## PORT OF WILMINGTON UPGRADES TO THE SOUTH GATE COMPLEX FOR

NORTH CAROLINA STATE PORTS AUTHORITY

Addendum #2

March 2, 2020

E-001

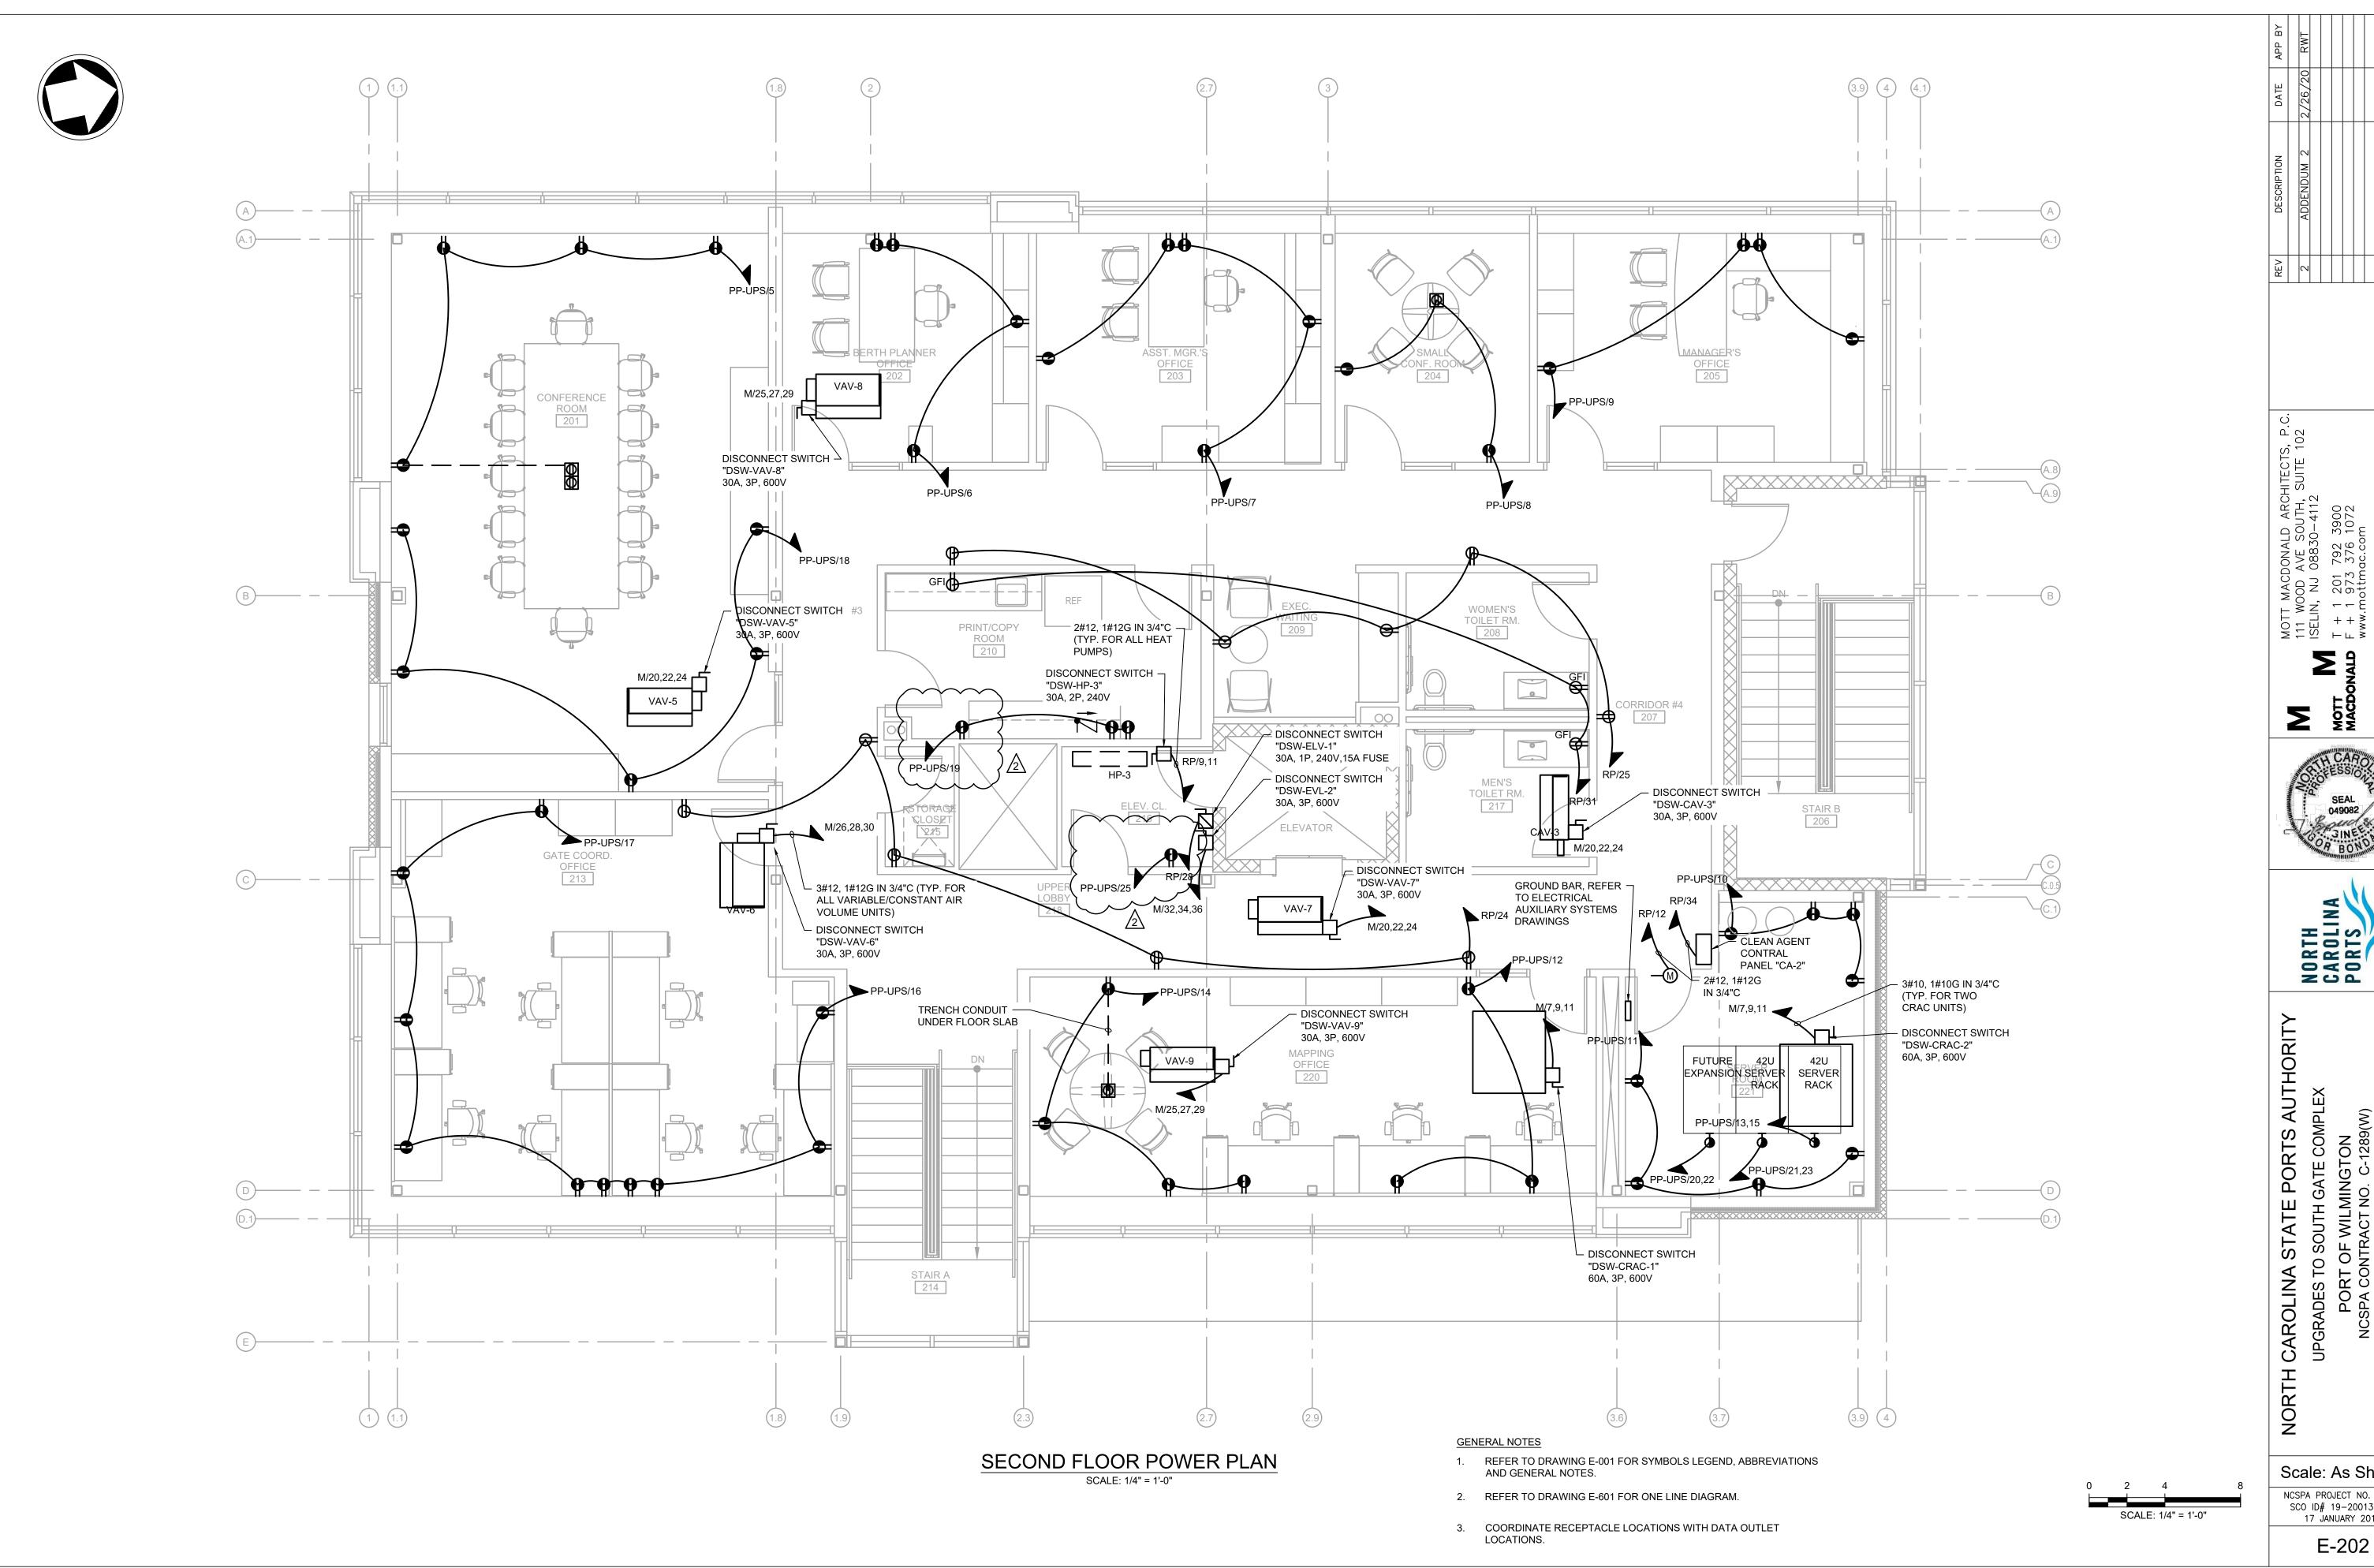
- q. PB034 Compressive Strength Mix
- 2. Revisions to Plan set:
  - a. CS-102
  - b. CS-103
  - c. CS-104
  - d. E-001
  - e. E-102
  - f. E-201
  - g. E-202

FP-001

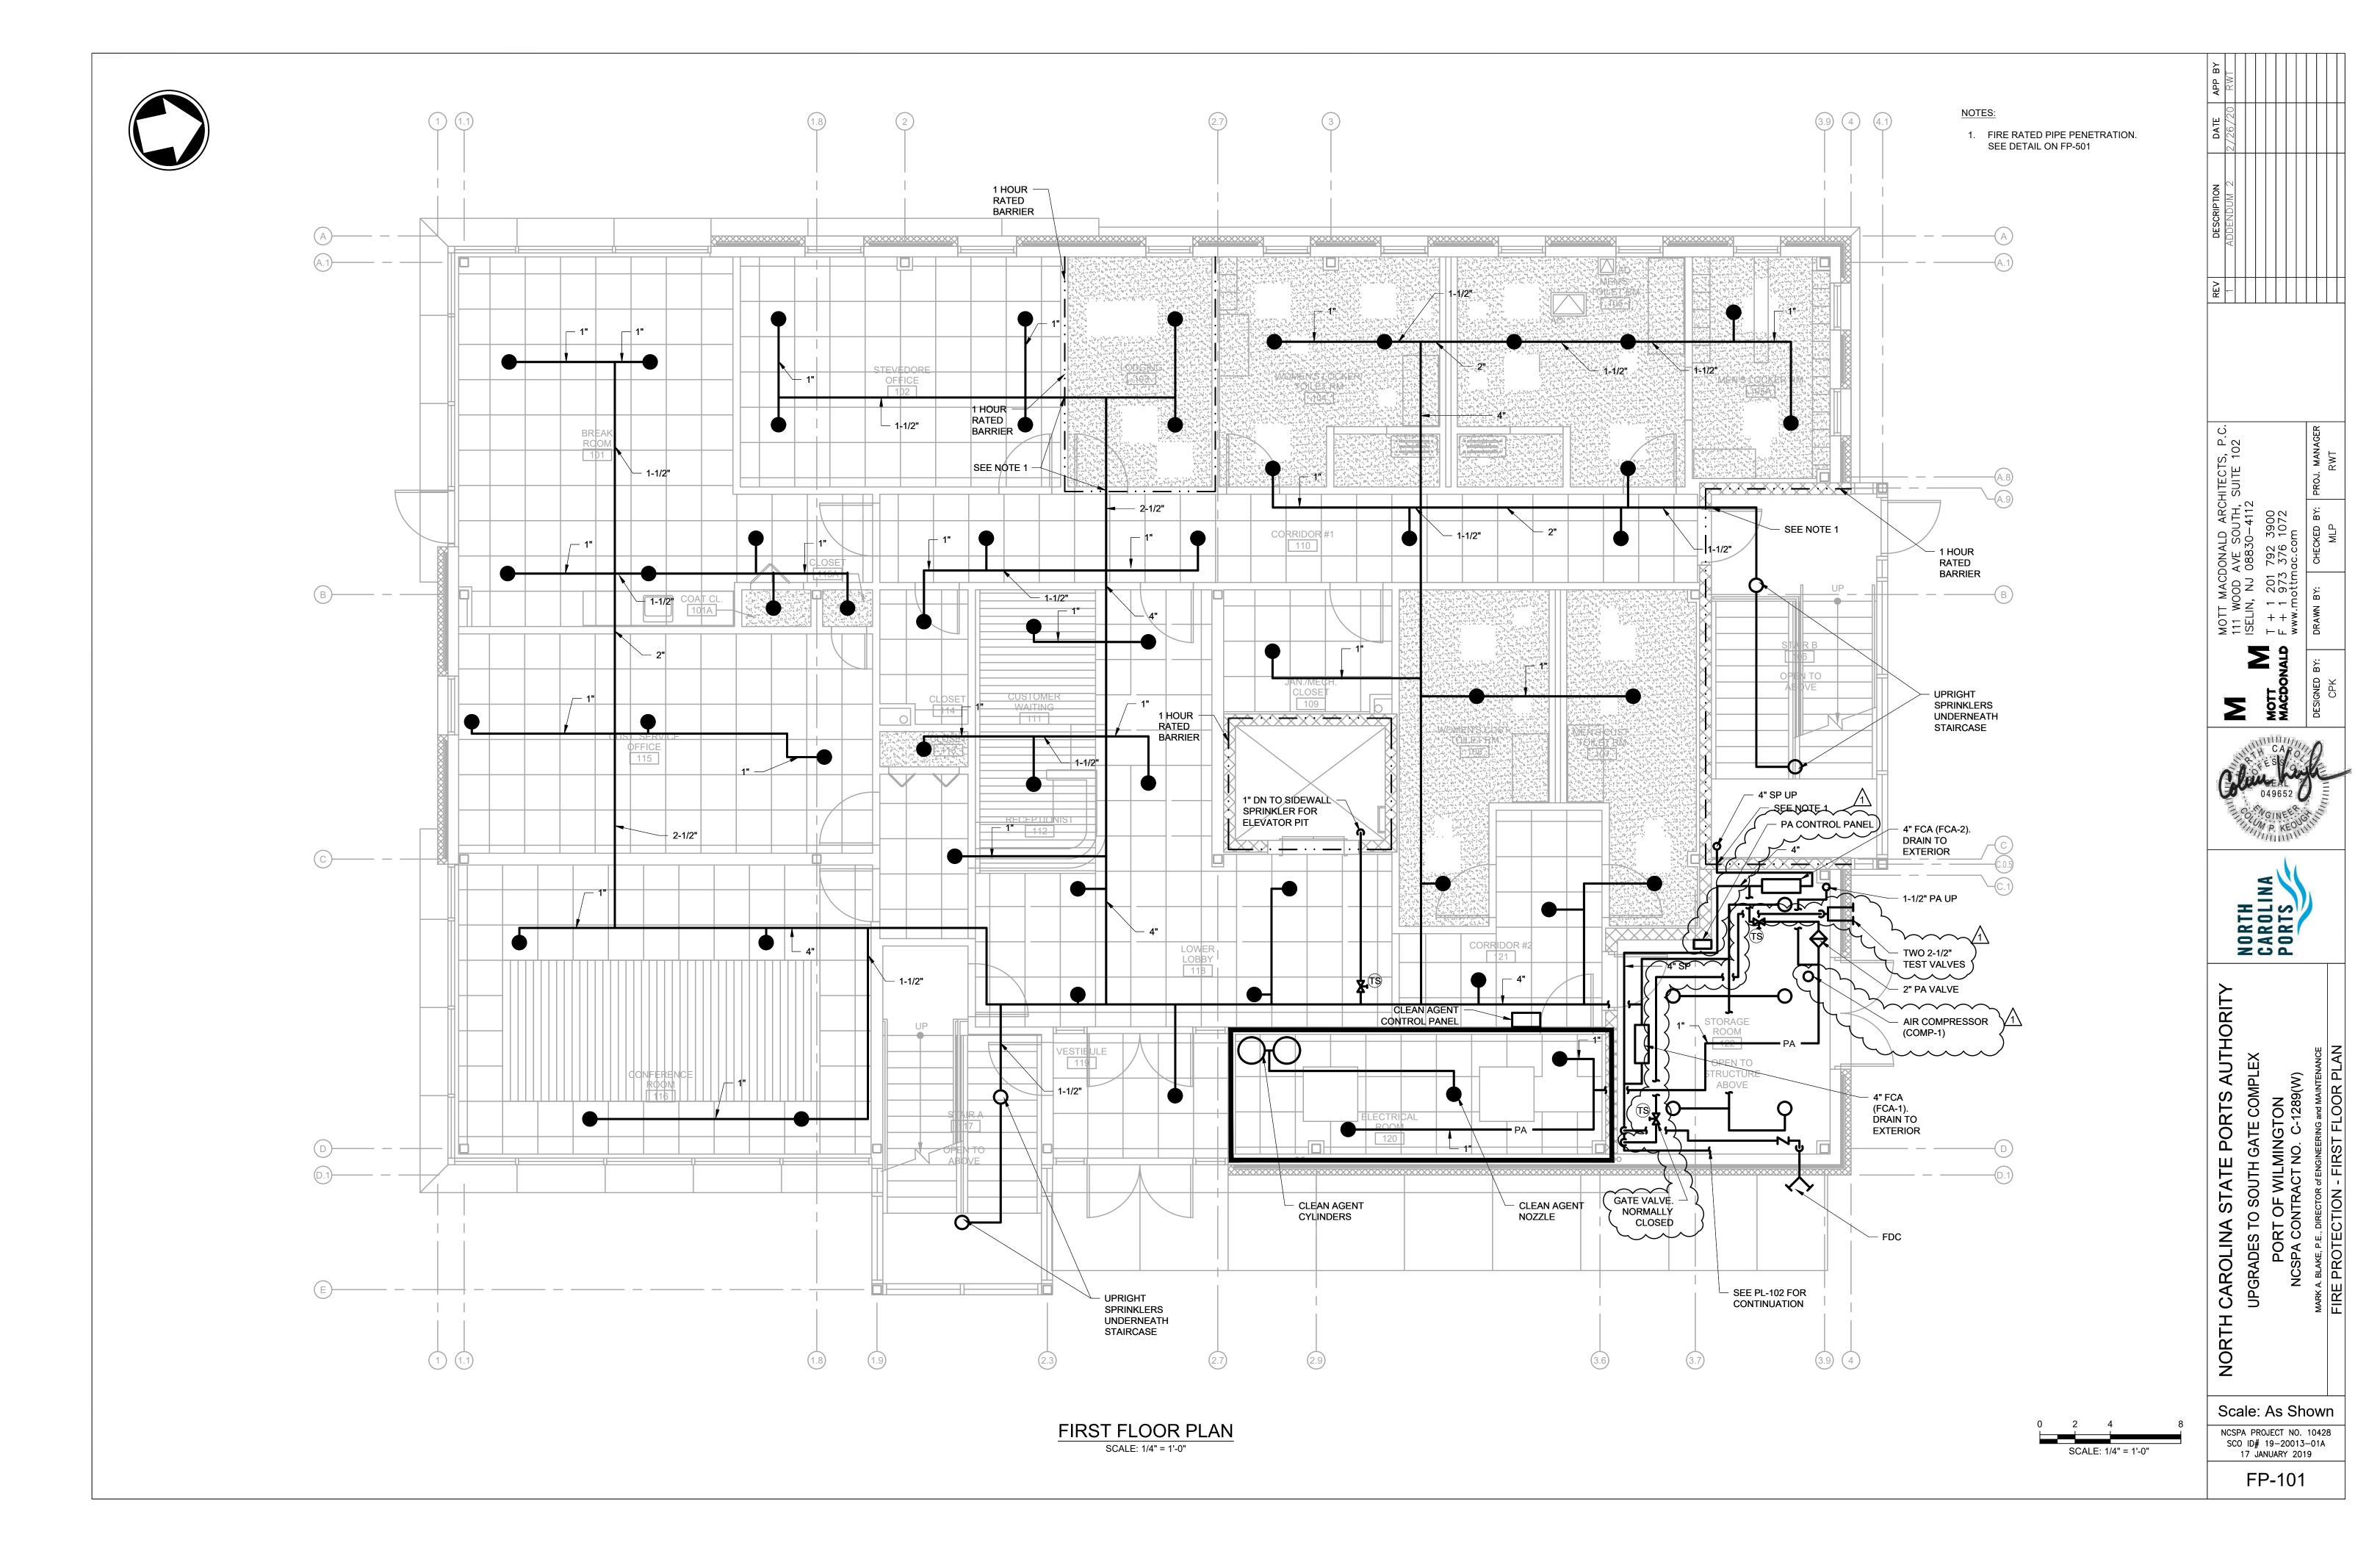
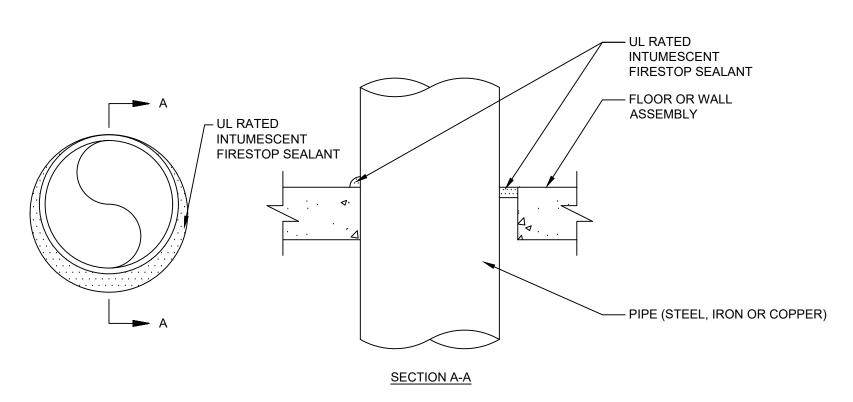
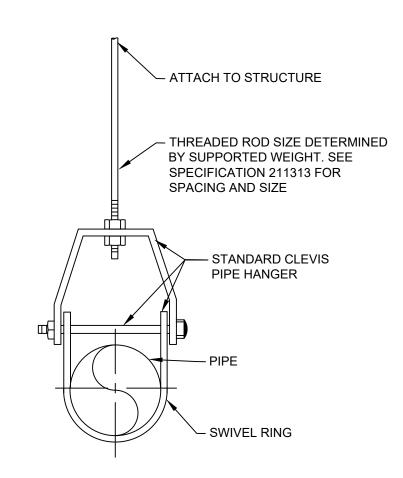
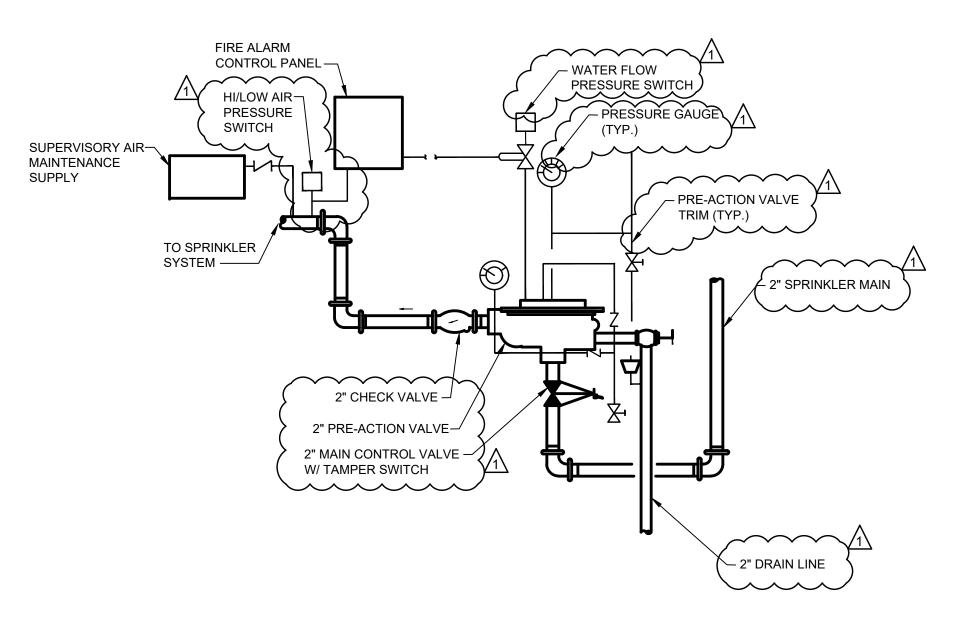
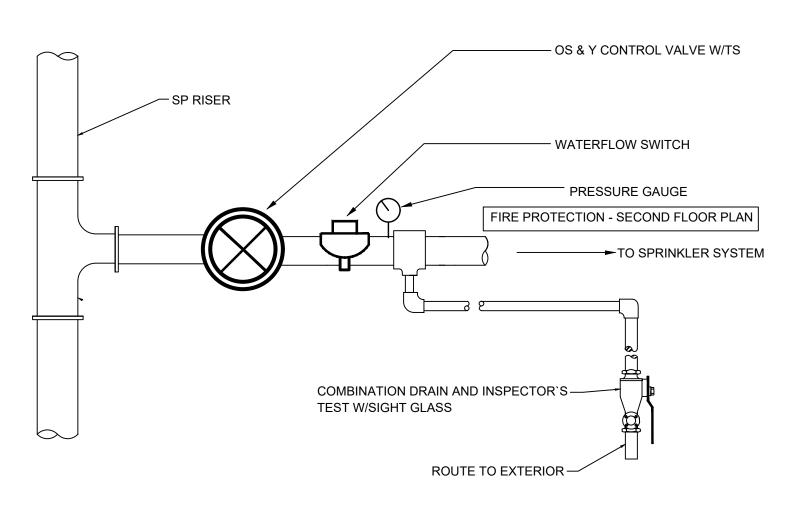
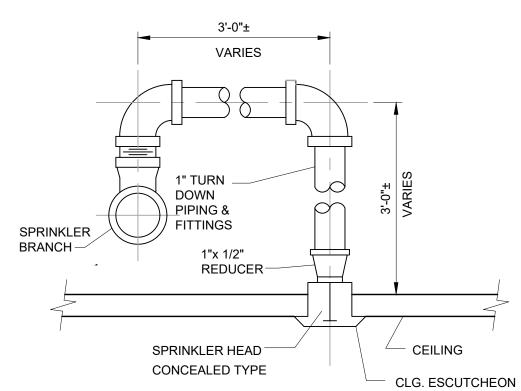
АРР ВҮ	RWT						
DATE	2/26/20						
DESCRIPTION	ADDENDUM 2						
REV	1
